3.6 ESD Commitments - Ratings

3.7 Facades

4.0 Design Development

Neighbourhood Centre Exploded Perspective - Layout, function and use

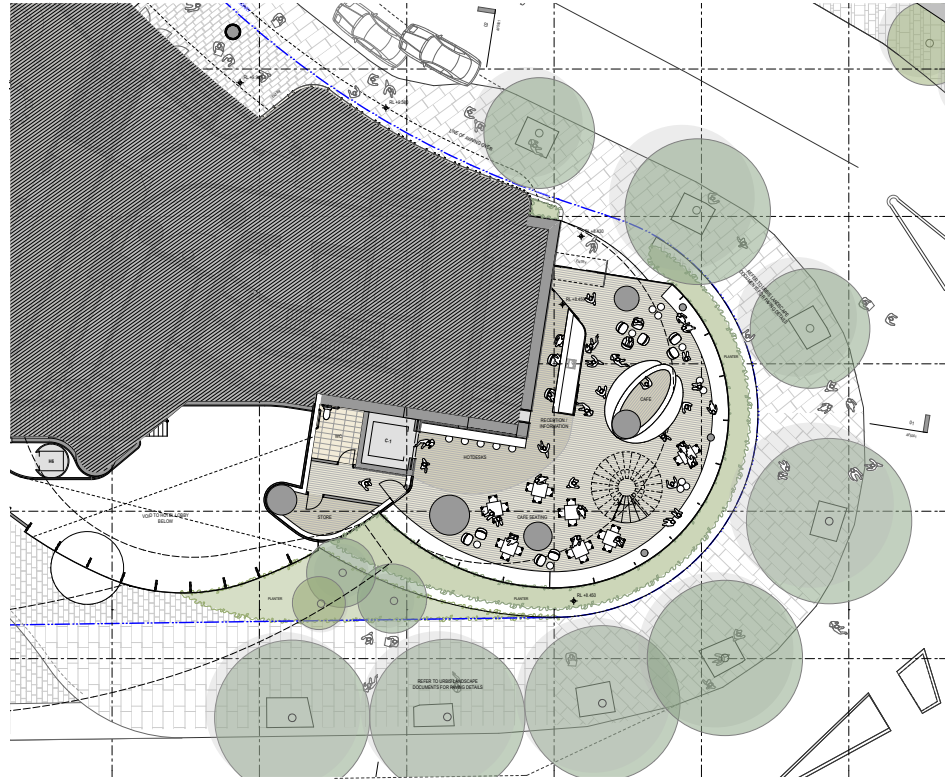
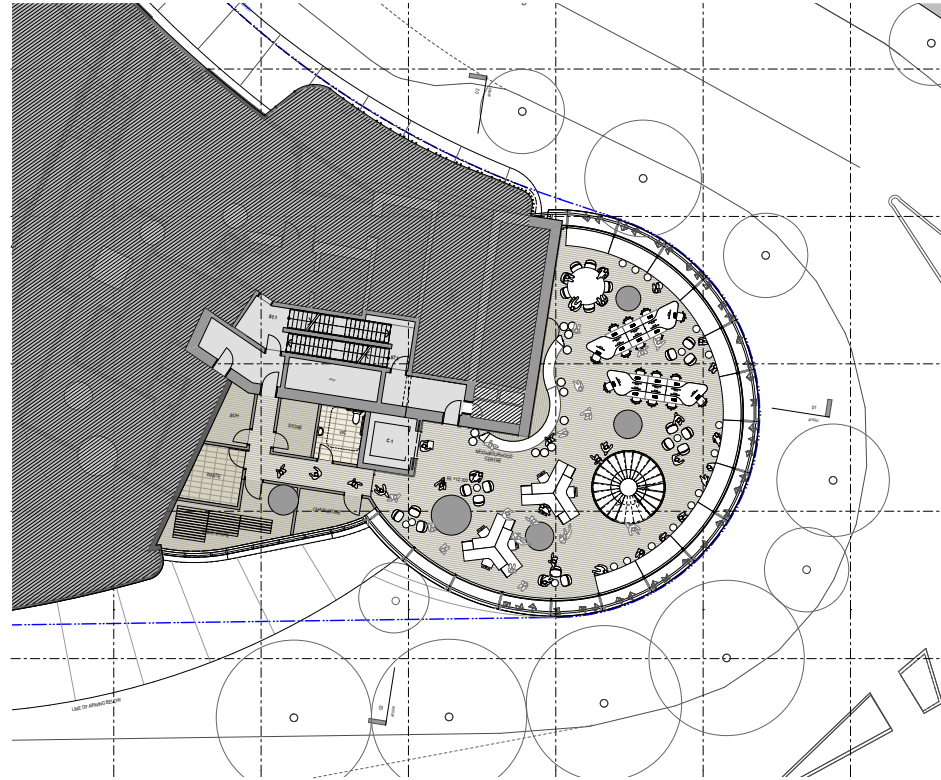
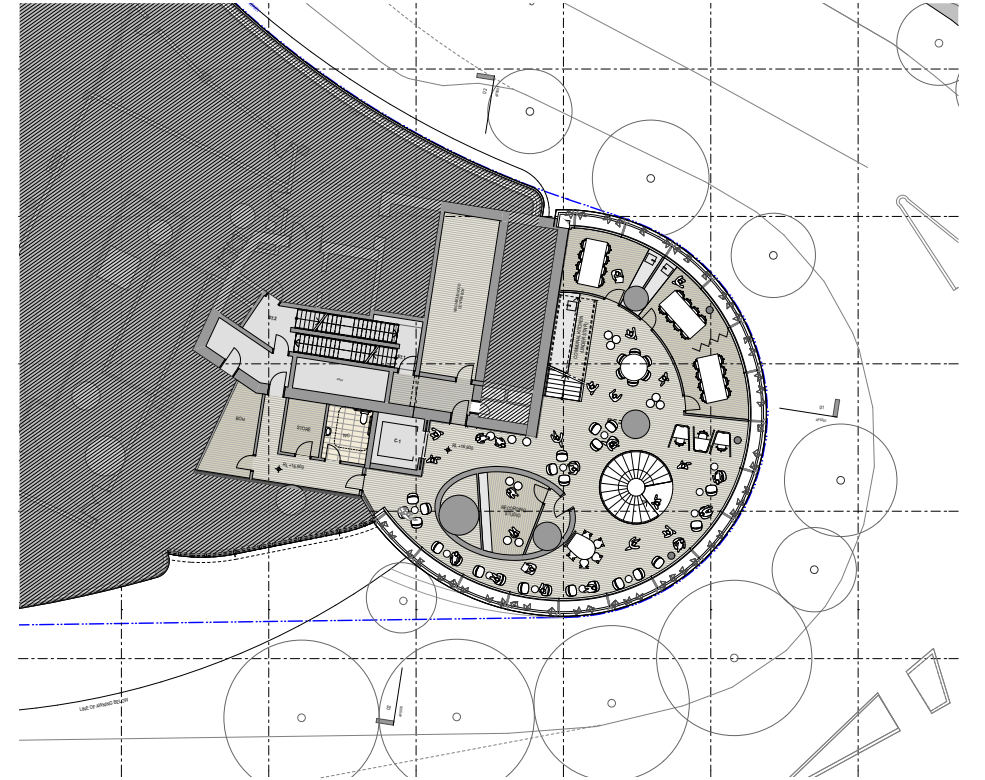
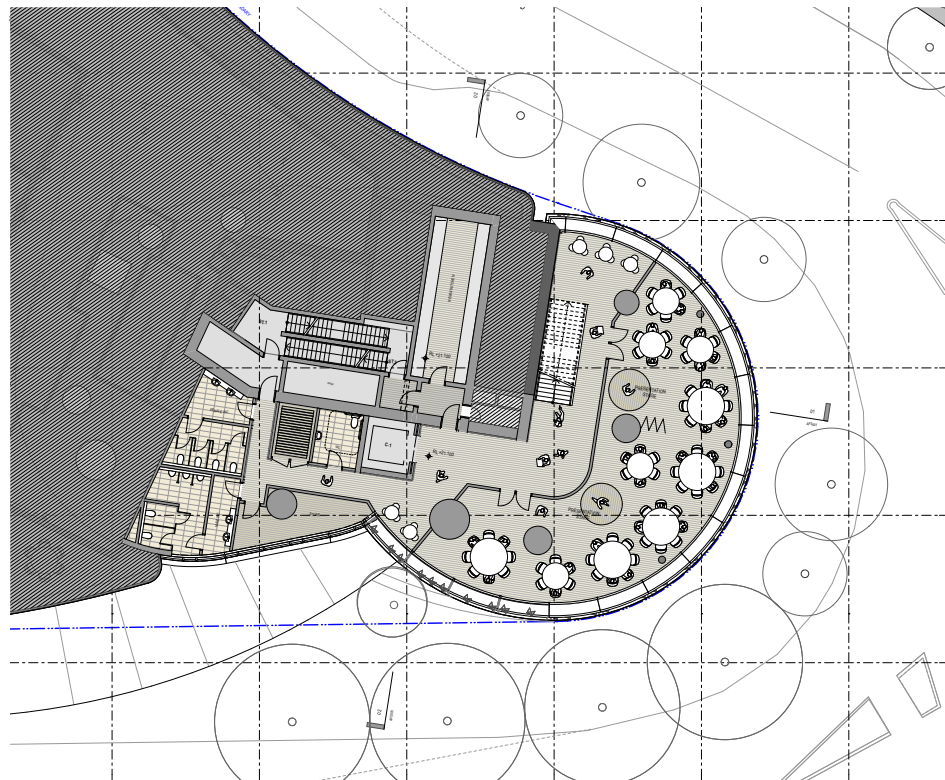
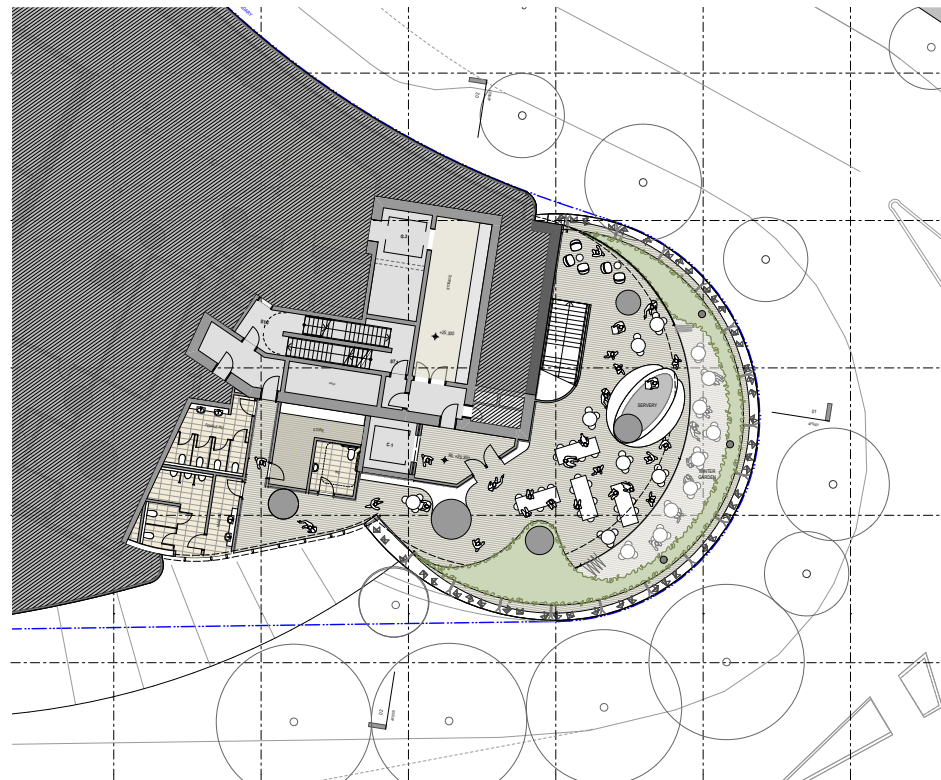
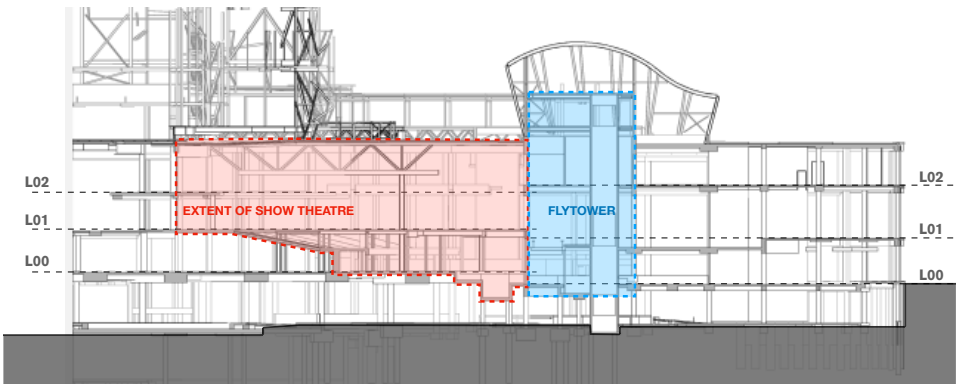
The City has raised concerns with the level of detail in planning, arrangement and functionality of the Neighbourhood Centre proposal. Through continued design development and communication with the City and the Department, a set of developed plans have been provided to convey the proposed use, layout and functionality of the space.

In response to feedback received during the City of Sydney meetings the following amendments have been made:

- Connection to the mains good lift (which in turn connects to the loading dock) was provided at Level 04. From here, goods are transferred to the dedicated Neighbourhood Centre goods lift.

- A reheat kitchen facility is provided at Level 03 with the blind lift lobby, i.e.: below the goods lift lobby as provided at Level 04 (see above).
- Internal walls and fixed furniture are shown to facilitate the nominated functions.

- The vertical circulation strategy was reworked to allow for more flexible planning for Levels 03 and 04,ie: the spiral stairs is replaced by a linear stair.

- Storage areas and amenities have been planned to ensure appropriate functionality.
- Level 00 shows a cafe serve very area as appropriate for the Social Enterprise cafe as proposed.

- An accessible WC is shown at Level 00.
- L02 spaces are now serviced with kitchenettes as appropriate for use as a Collaborative Hub.
